# SERVICE BULLETIN

## PROBE RODS AND CONNECTORS.

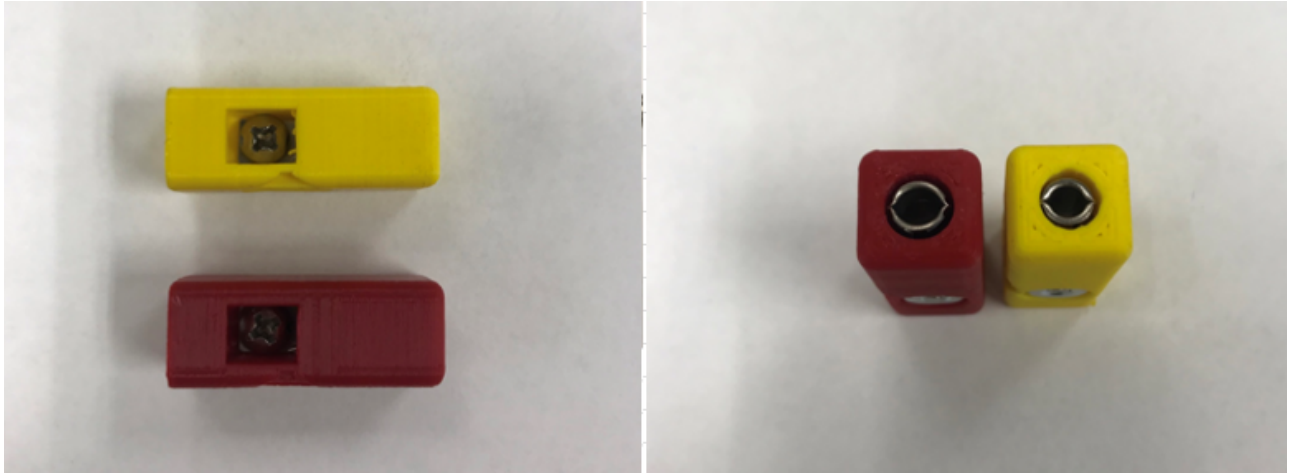
1. The new style probe connector features a push on style fitting and a two-piece compression style wire connector.
2. The new style probe rod no longer will contain a threaded rod end. Instead, it will be a tapered end with a smooth finish and a detent groove for the probe connector to lock on.

3. We are also offering this as a premade pig tail and will contain the new style push on connectors, thermocouple wire and the female connector jack.
4. Along with the new design the premade pigtails will contain heat shrink protection along with silicon tubing around the thermocouple wire for added protection. (See photo's below)

6. Moving forward Granco Clark will not offer the Threaded style probe rods. The new style push connector will work on the threaded end and cause no issues to temperature reading or to tightness on the rod end.

5. New part number as listed.
  - Red push on connector. Part number 599010000012.
  - Yellow push on connector. Part number 599010000013.
  - Premade pig tail. Part number 47035.09.
